ATTACHMENT A

KENWOOD COMMUNITY & SENIOR CENTER ATTACHEMENT A

ADDENDUM #1 – REVISED DRAWINGS

8 SECTION DETAIL
3/4" = 1'-0" MONUMENT SIGN

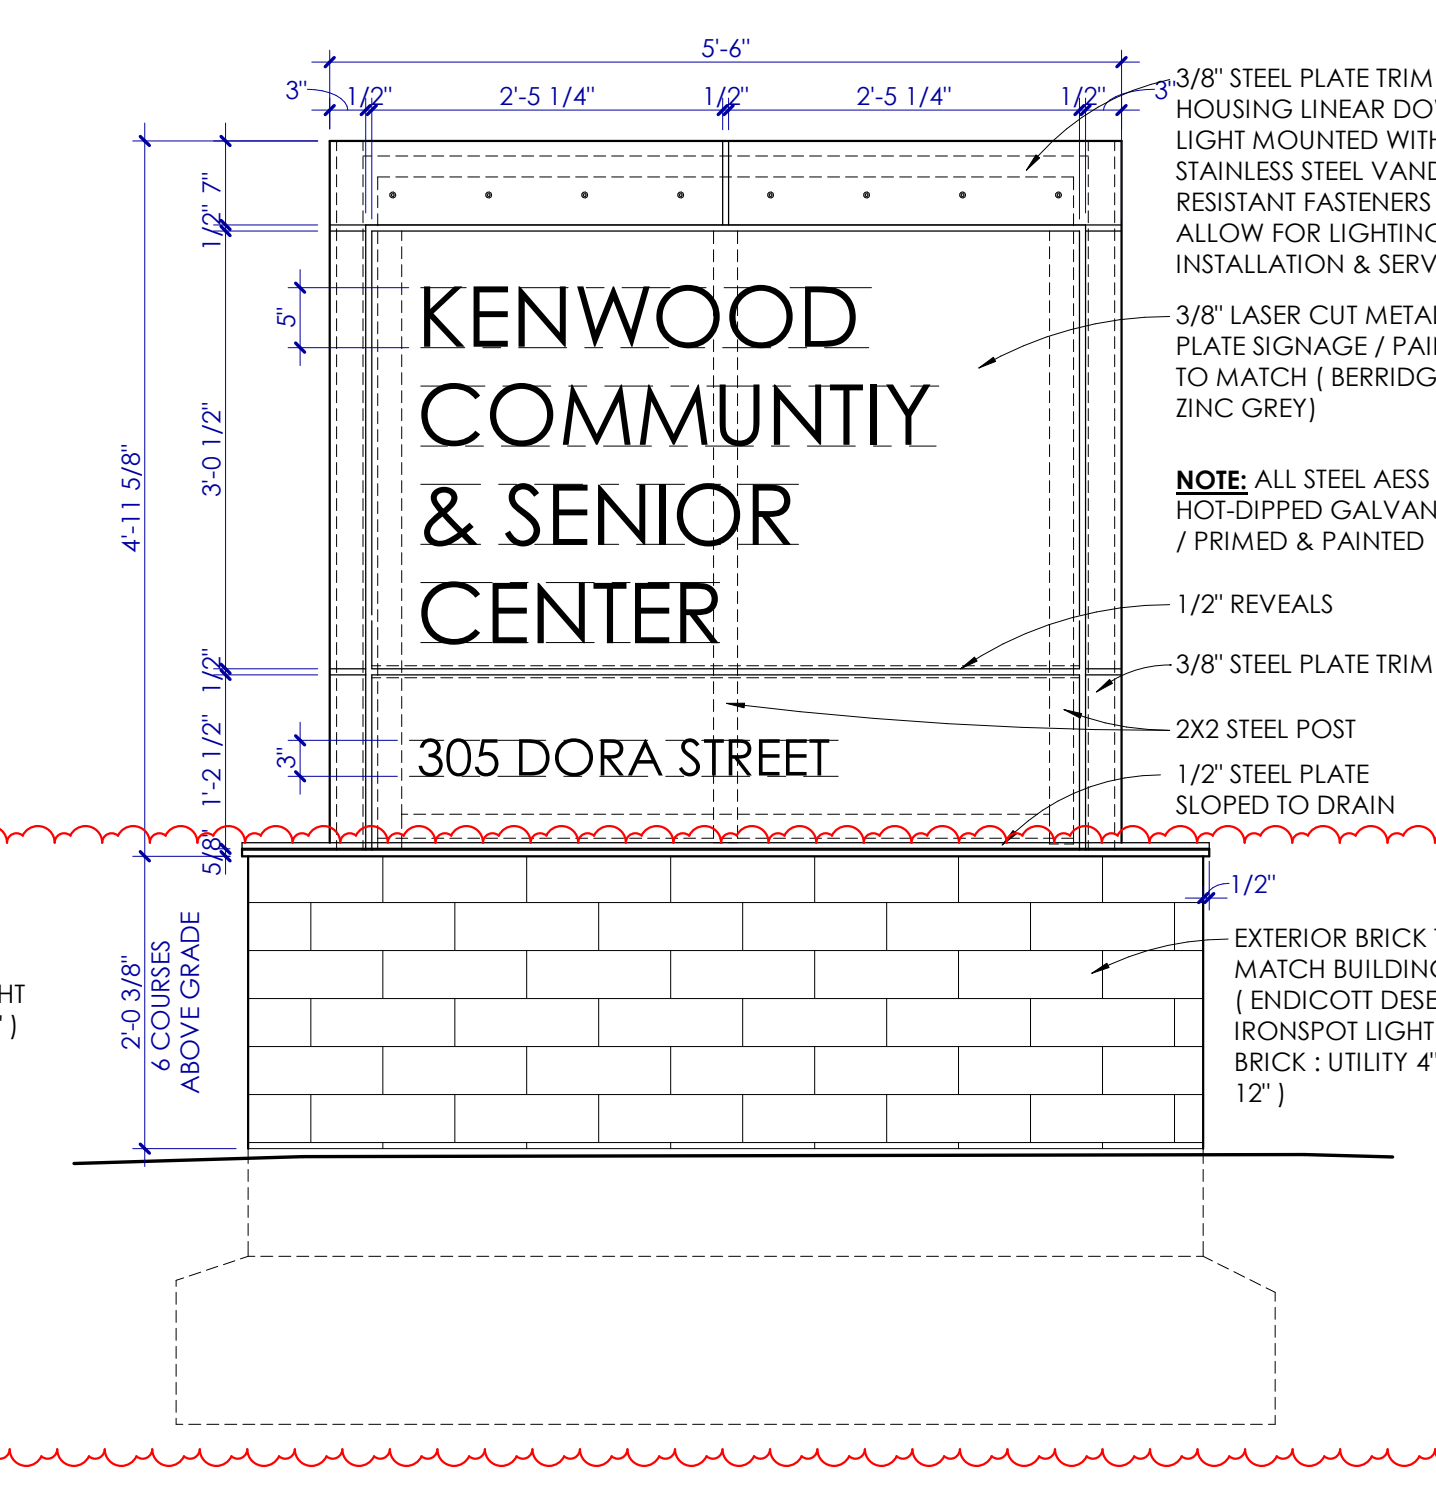
Details for the monument signage have been revised to correctly illustrate the required structural foundation / supports. Refer to attached revised sheets A2.4 & S3.13.

8 SECTION DETAIL
1" = 1'-0" ALUMINUM FLOOR HATCH

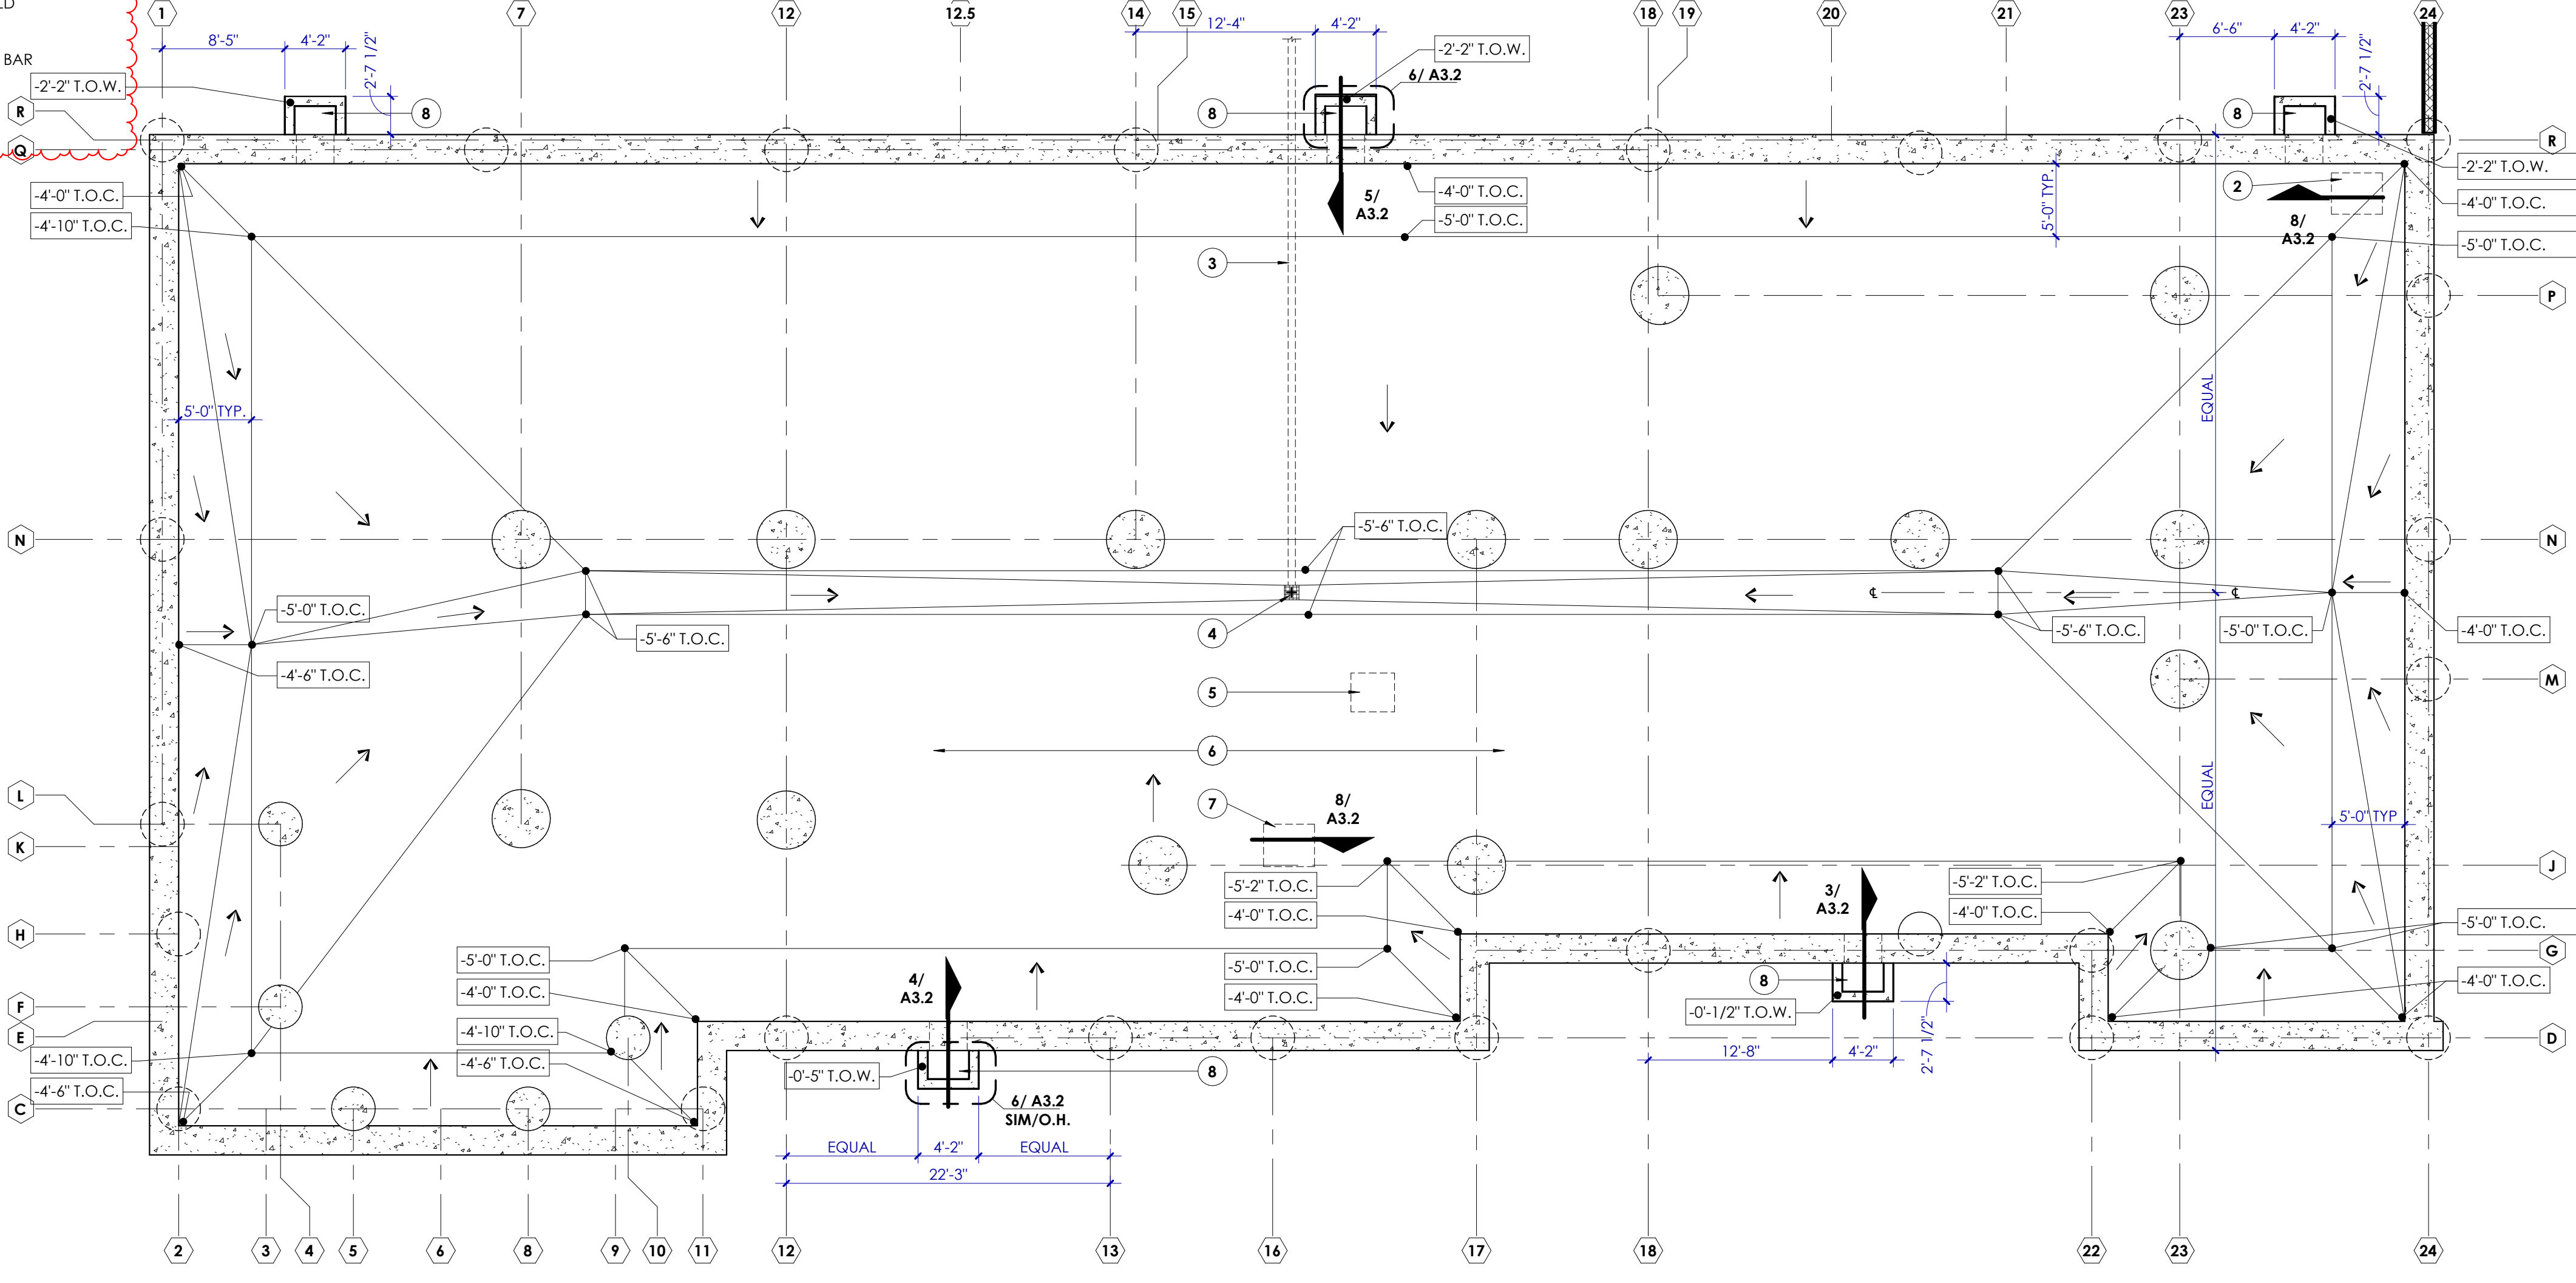
The access hatch provided in the warming kitchen has changed orientation to allow for better access to the specified grease interceptor, refer to attached revised sheet A1.3.

project number 24-04
 date 1.5.26
 sheet number **A7.2**
 Beaty Palmer Architects, Inc. 110 Broadway, Suite 600 San Antonio, Texas 78205
 Voice 210.212.8022 Fax 210.212.8018 www.beatypalmer.com
 BEATY PALMER ARCHITECTS

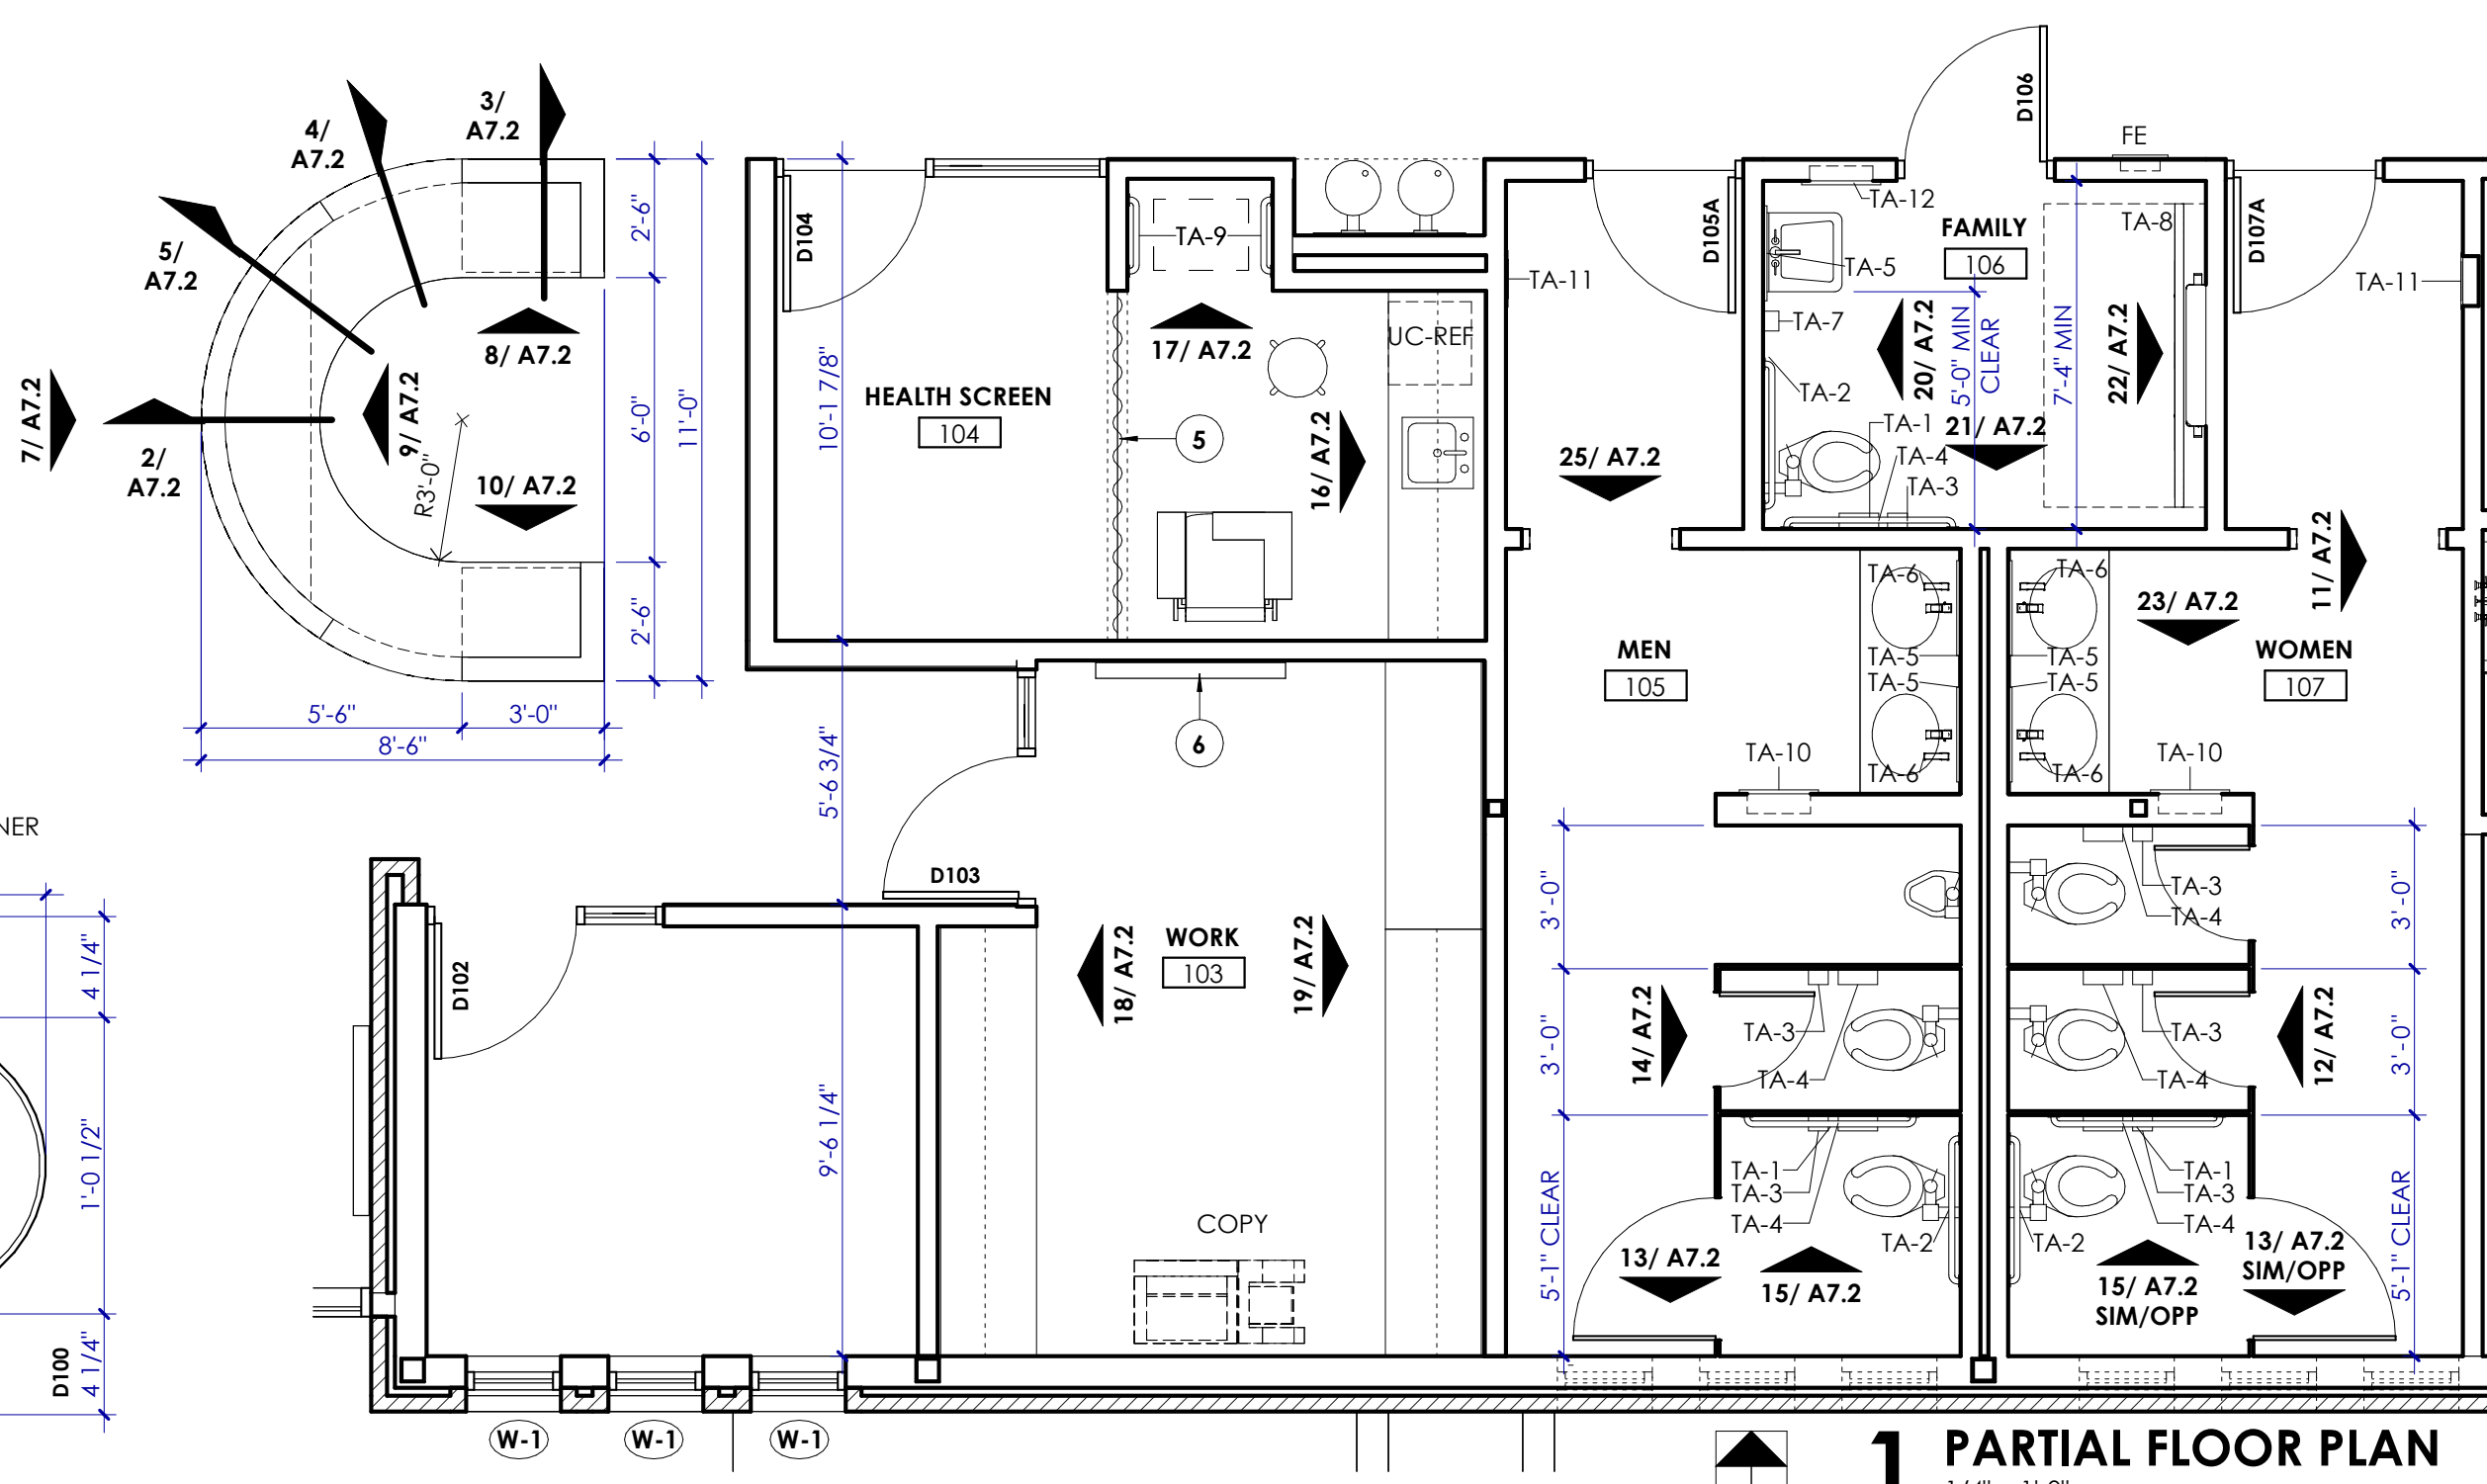
The Millwork in health screening has been revised to eliminate the countertop surface above the refrigerator. Refer to attached revised sheet A7.2.
